EAST QUARTER STAGE 3

93 Forest Road Hurstville

URBAN DESIGN REPORT

Revised Design Responses to DA2013/0385 Hurstville Council Development Assessment Report

FIGURE 3-1: REVIEW OF FORMER DESIGN

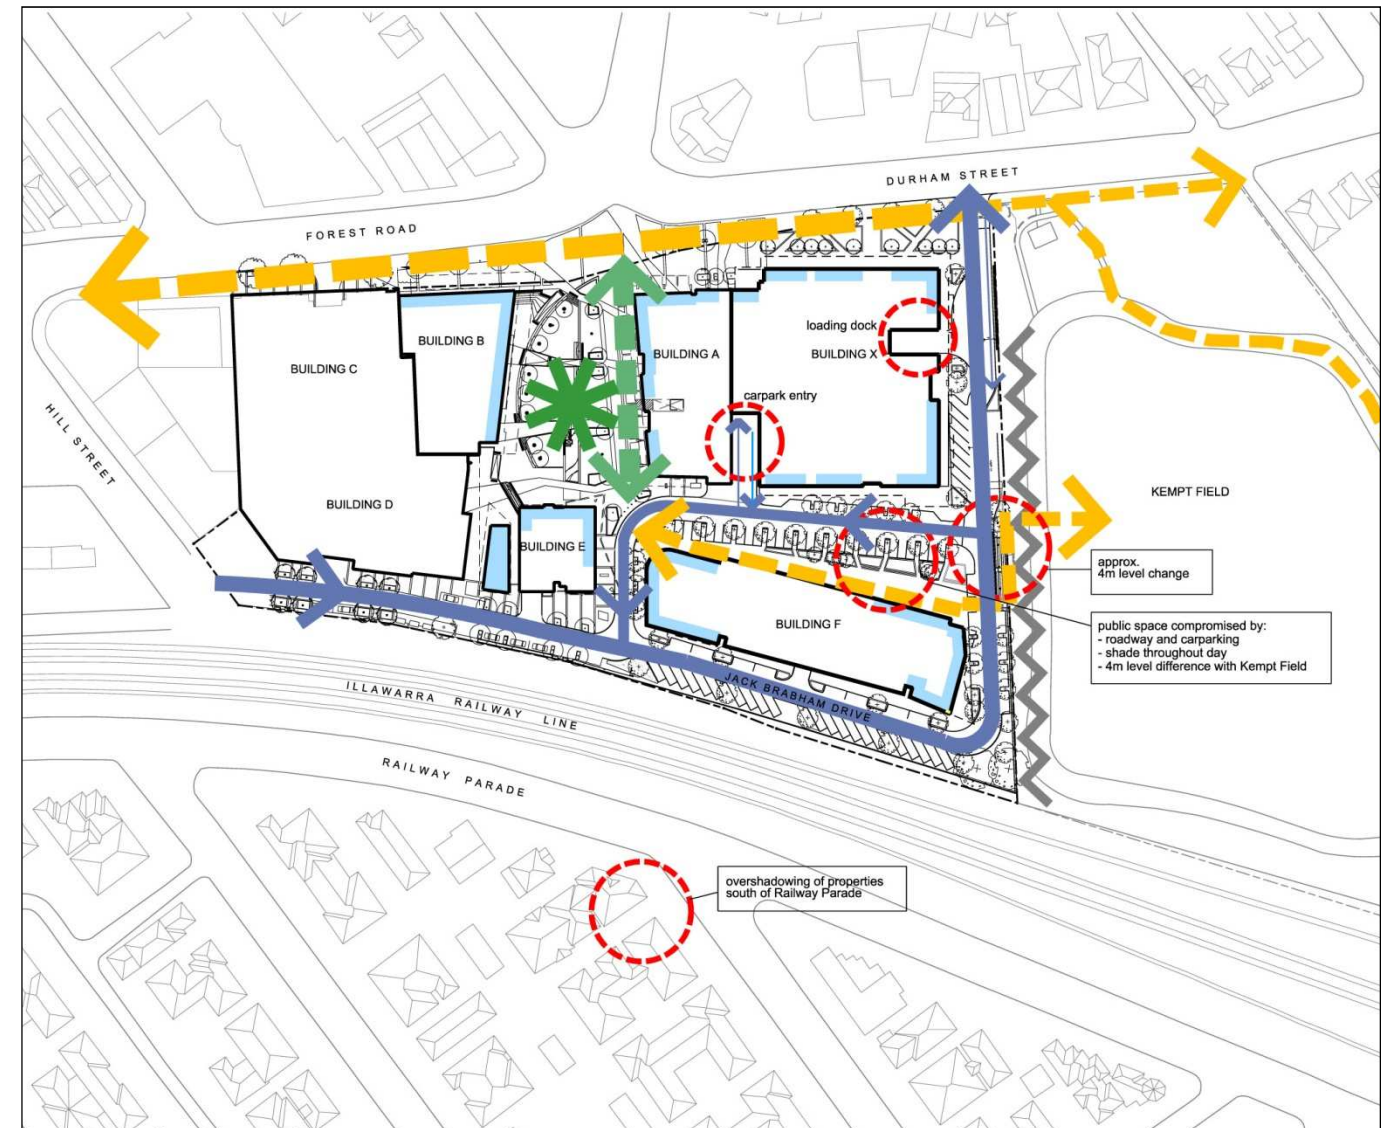
1. Context

- Substantial areas of on-grade carparking detracted from the quality of the public domain.
- Visual impact and overshadowing impact to residential areas to the south of the railway line are critical considerations.
- Building F did not satisfactorily respond to its context.

- The scale of Building F was unacceptable.

- The addition of 6 levels to Building F was not acceptable due to potential negative impacts including:
 - Compromising the landmark presence of Building E on the axis of Forest Road.
 - Additional overshadowing of the park, public domain and residential development on the south side of Railway Parade.
 - Potential increase in wind and impact on the amenity of public spaces.
 - Increased demand for parking onsite reducing the potential for deep soil planting.
 - Strong adverse visual impact particularly when seen from the south.
 - Increasing scale and appearance of built form as seen from Kempt Field.

- The streetscape and ground level offer little open space amenity.
- A significant level change occurs adjacent to Kempt Field.
- There is no provision of deep soil.

- Retail configuration requires resolution.
- Communal rooftop spaces should work effectively.
- Carparking to the north of Building F creates an inactive street edge.
- Proposed south facing communal open spaces at level 18 of Building F are in shade.
- Balconies of Building F to be more equitable in size.

- Lobbies of Building F, at the at the back of the building, are potentially insecure.

- Façade treatments of Building F do not alleviate the aesthetic impacts of such a large, bulky building.
- Public domain appears treated as residual space.

FIGURE 4-1: REVISED URBAN DESIGN APPROACH

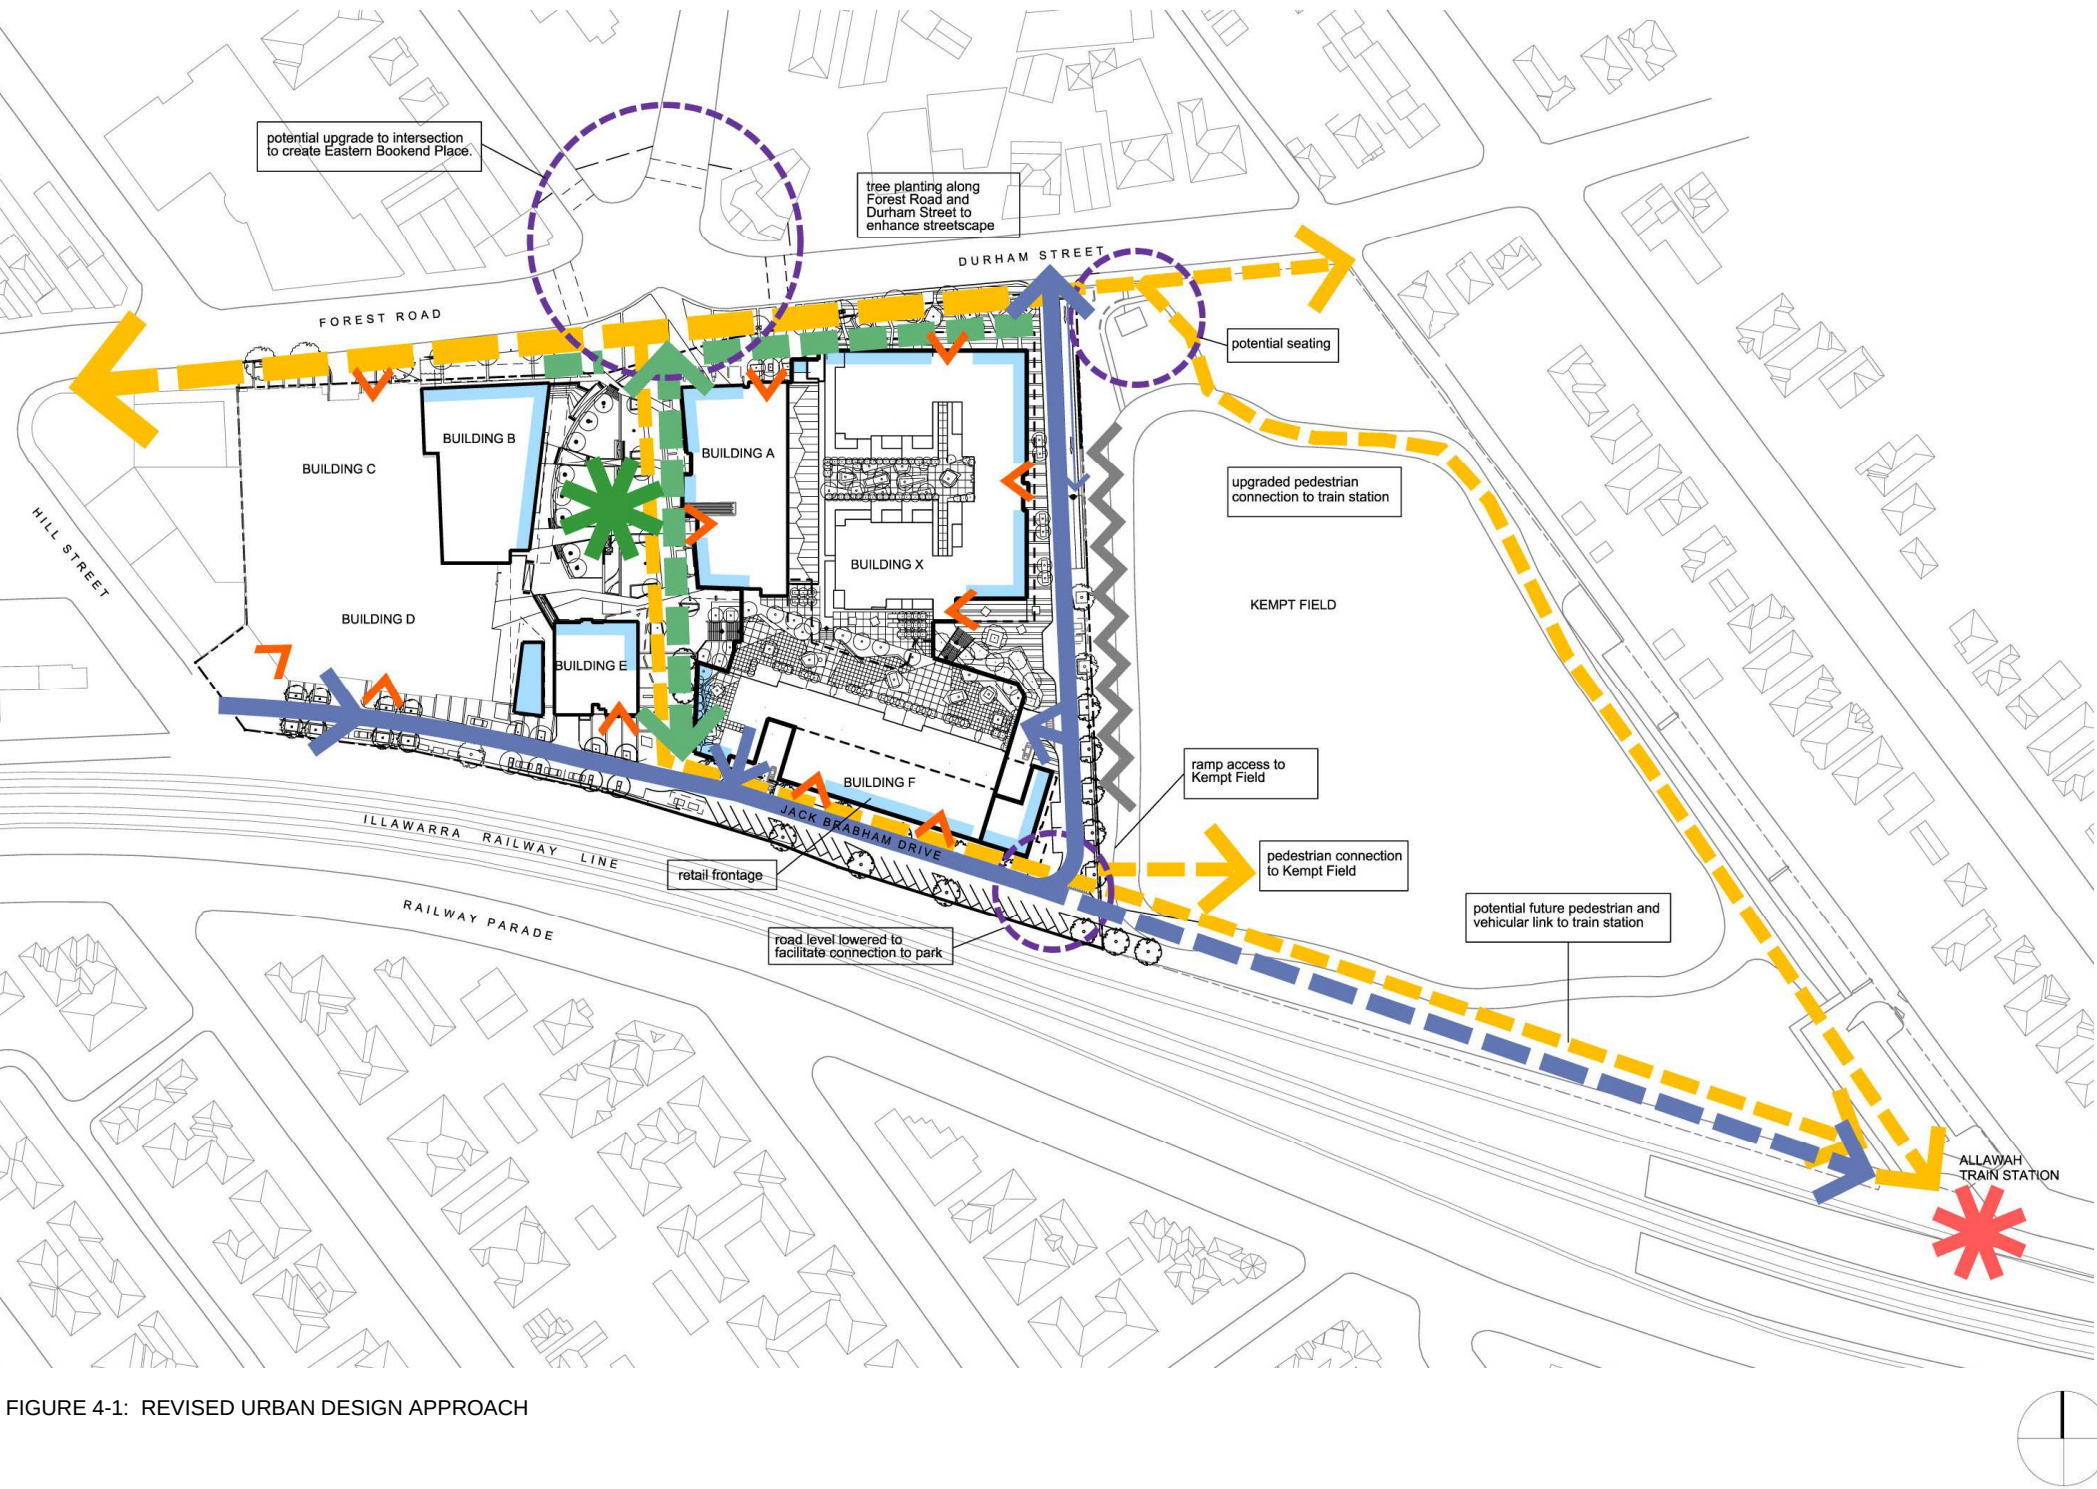
As part of our Urban Design analysis and site investigations undertaken DEM has reviewed the issues raised by Council in relation to the previous DA design (November 2013). Our review has identified that a revised design approach could be adopted for the site which would largely address Council's concerns and which would lead to a higher quality and more vibrant urban outcome.

- The revised design incorporates major pedestrian east/west linkages along Durham Street and Jack Brabham Drive. These new linkages provide safe and well activated pedestrian routes from both the Hurstville Town Centre and from within the site to Kempt Field and Allawah Railway Station for the public, local commuters and residents.
- An active street plaza space is located along Durham Street adjacent to Building X.
- The previously proposed service road link road is now deleted and replaced with an additional open space area as an extension of the central plaza constructed in Stage 2. This creates the a major pedestrian link between Durham Street and Jack Brabham Drive.
- Communal / public open space is provided through a combination of roof top terraces and a new centrally located landscape podium area created between Buildings F and X.
